Plan Review & Routing Comment Form

Project: Auburn Community Commons - Development Plan
Revision: Preliminary
Type: Development Plan
Logos ID: PROJ-PUBLIC - 2020-00000002
Due Date: **Jan 15, 2020**

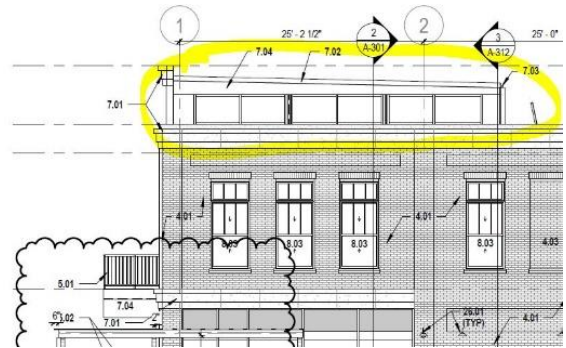
1. Security concerns with opened all day, every day
2. We’d strongly encourage incorporating some sort of storage area within the maintenance space.
There always seems to be a need for secured storage areas in downtown.
3. Please consider alternatives to the roof line to allow for natural light and air:
 - Leaving the roof off the open area and designing it to be an open air plaza. It could still have the columns and trusses.
 - Similar to TQS, one portion of the roof being taller than the others with some open air vents (see image)
